Product Advisory

Issue Date: March 6, 2019

Broadcom DCSG adapter kit boxes currently include a black label on the edge of the box that includes adapter features and the product barcode. This advisory notifies customers that this black label is being removed and replaced with a barcode label only.

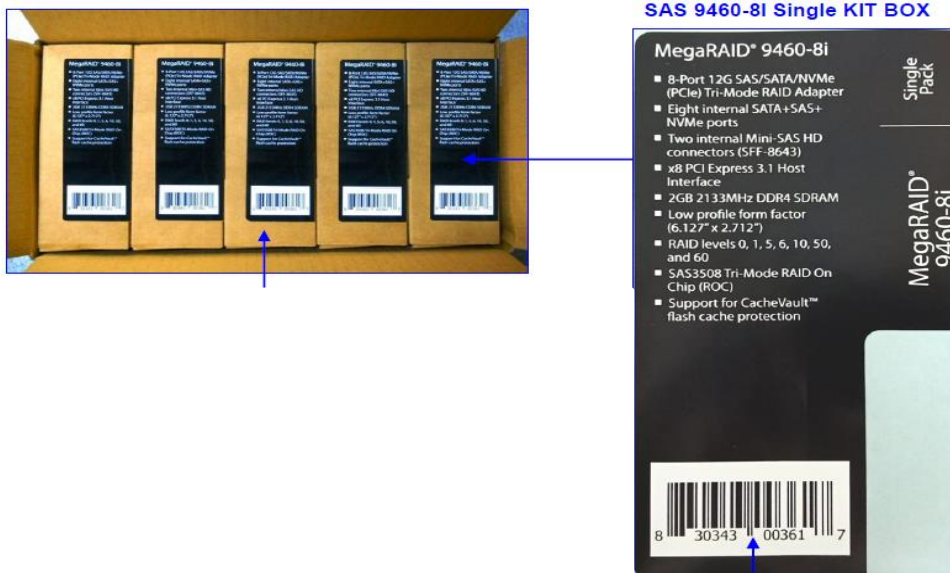
The black feature label on the edge of the adapter kit boxes is being removed. It will be replaced with a white barcode label including the adapter name. This label will be placed on the edge of the box in roughly the same location as the existing bar code on the black label. An example of the label is shown here:
